2020/21 Annual Report of the Ground-Level Monitoring Committee

Project No. 941-80-21-61

- Appendix A: Recommended Scope and Budget of the Ground-Level Monitoring Committee for FY 2021/22
- Appendix B: Response to GLMC Comments

Figure 3-2

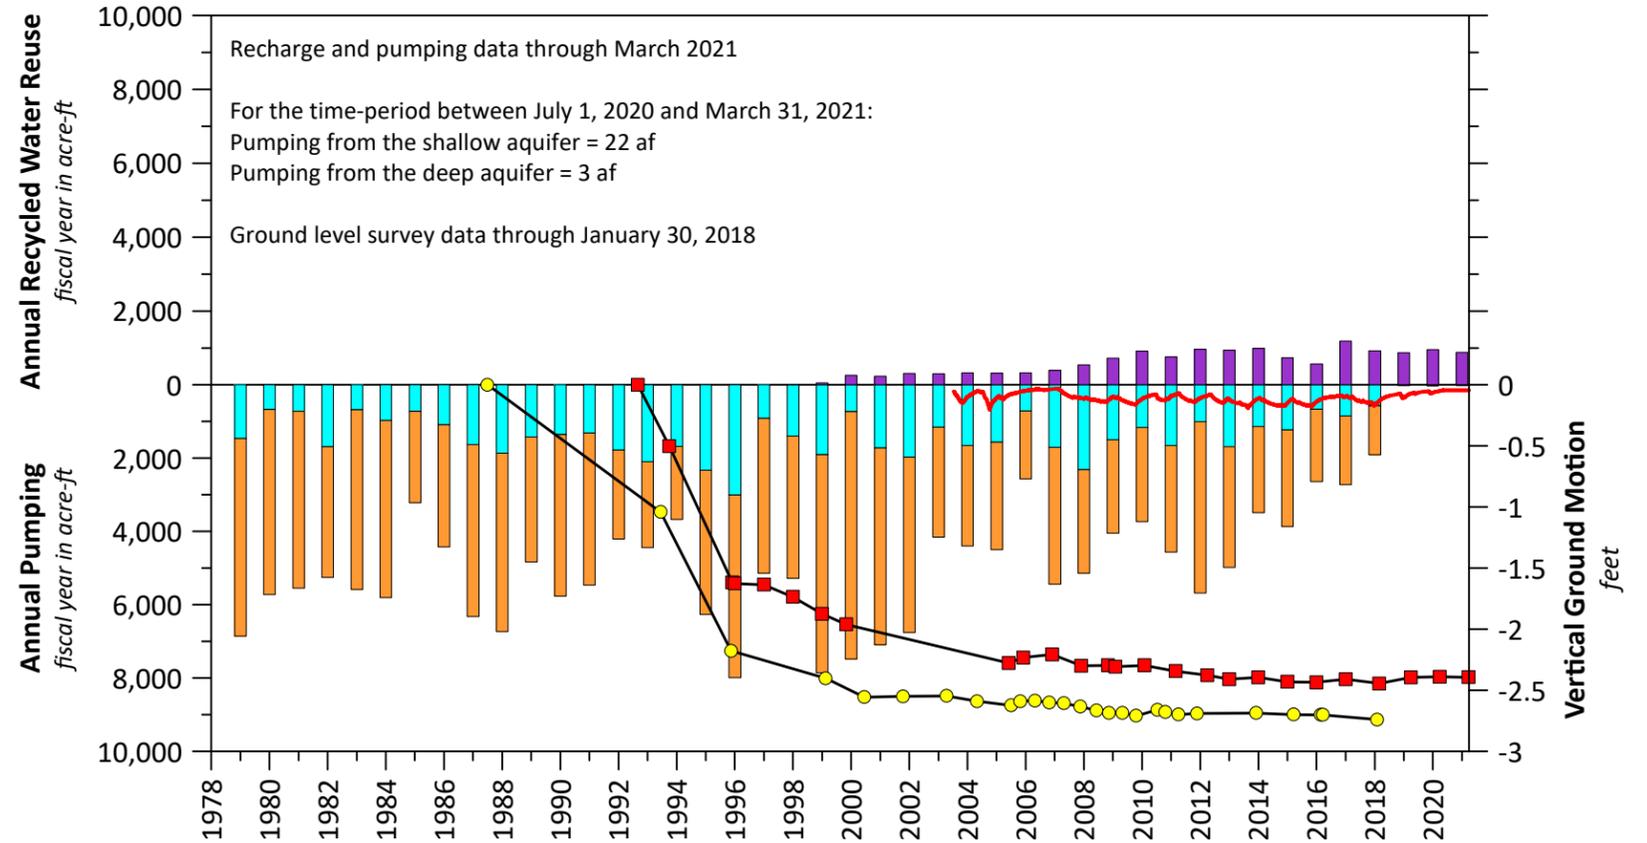
Comment 1 – Section 3.1 Managed Area and Figure 3-2

Figure 3-11

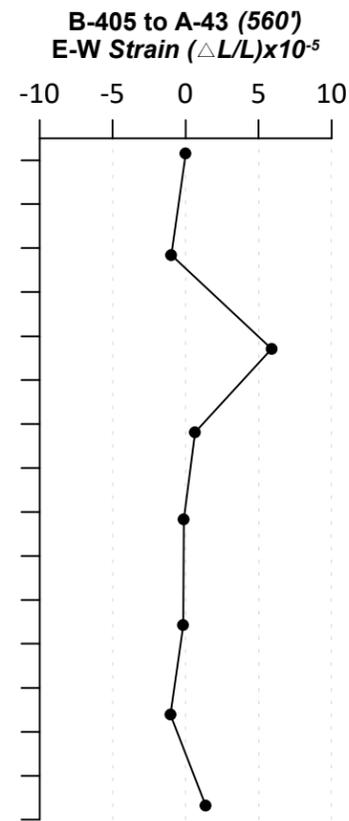
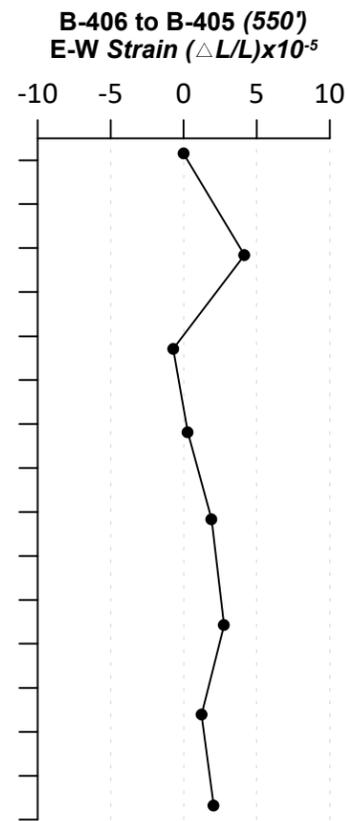
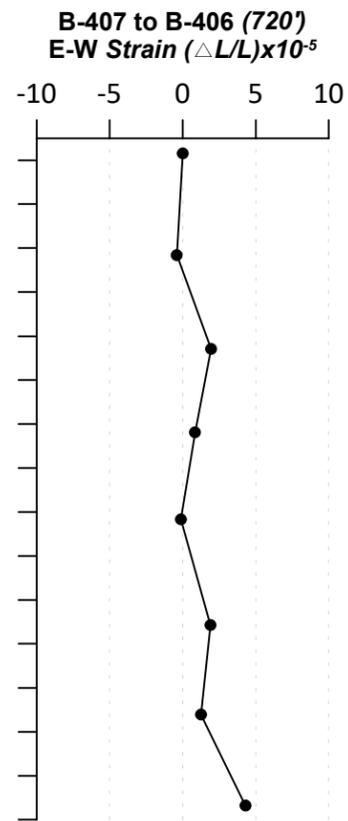
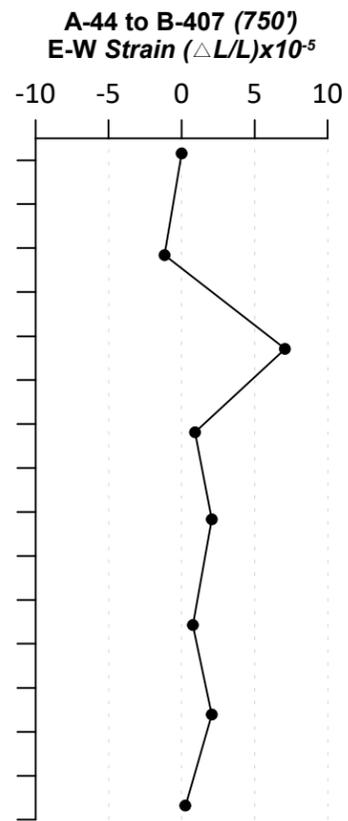
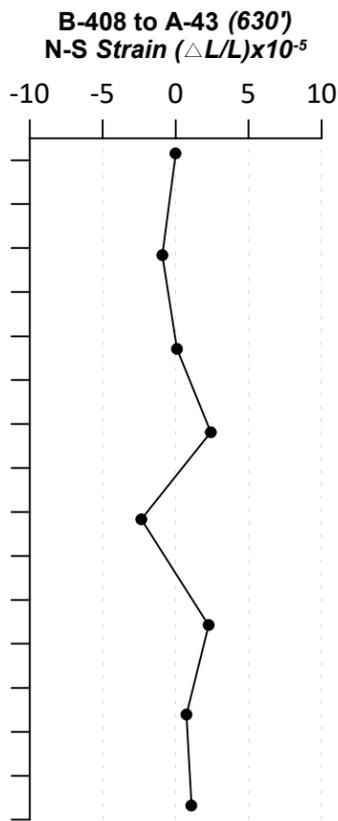
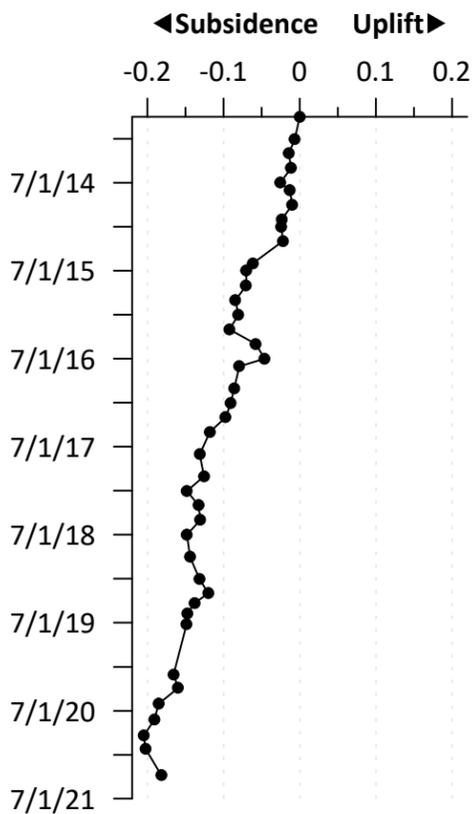
Comment 1 – Figure 3-11

During the September 30, 2021 meeting of the GLMC to discuss the draft 2020/21 Annual Report, Mr. Scott-Coe verbally recommended revisions to Figure 3-11. The recommended revisions included adding clarification to the figure's legend items and adding quarterly recharge from Northwest MZ-1 to the figure.

Figure 3-11 was updated in the final report.

Comment 11 – InSAR-Estimated subsidence and Model-Simulated Aquifer System Deformation

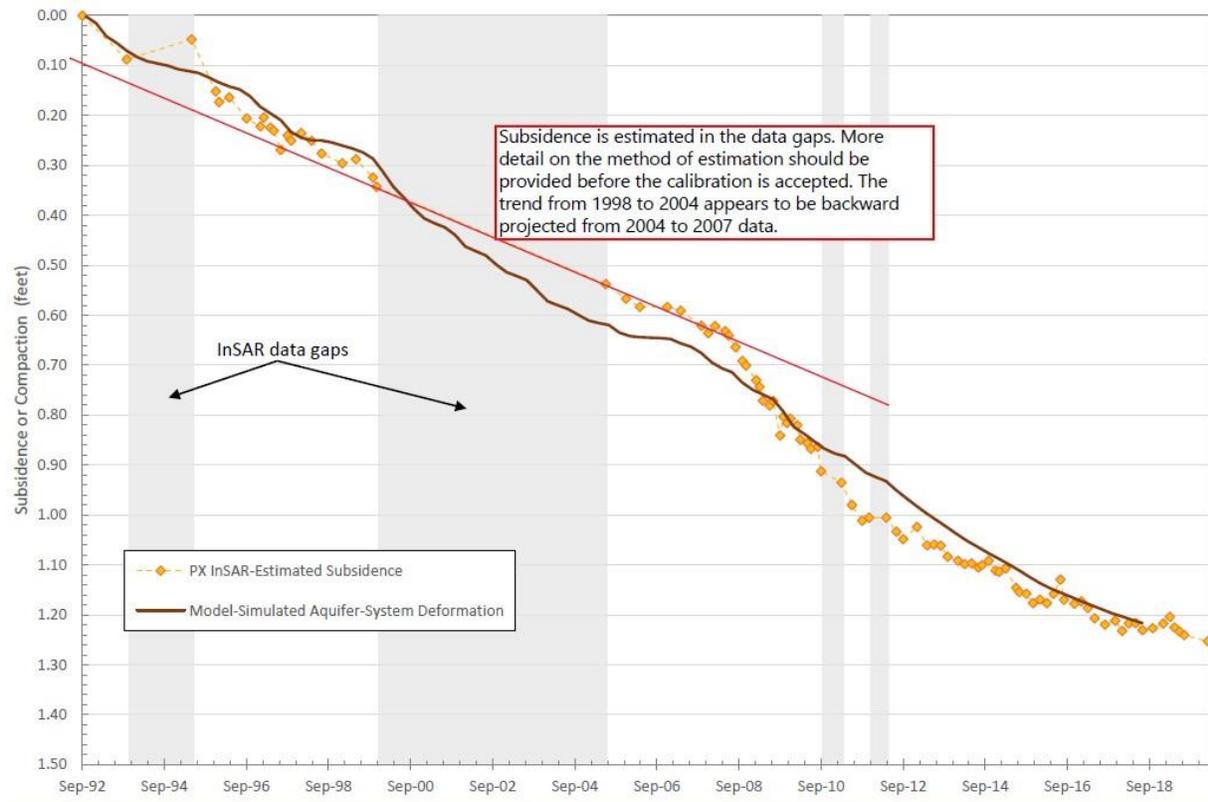
During the March 4 meeting, WY presented InSAR-Estimated subsidence and Model-Simulated Aquifer System Deformation for the PX 1D model. InSAR data gaps were shown, with the InSAR-Estimated Subsidence projected through the data gaps. WY did not provide the method used to estimate subsidence

in the data gap. Additional detail on the method should be provided before the calibration is accepted. The prediction trend appears to be backward projected from September 2004 to late 2007 levels.
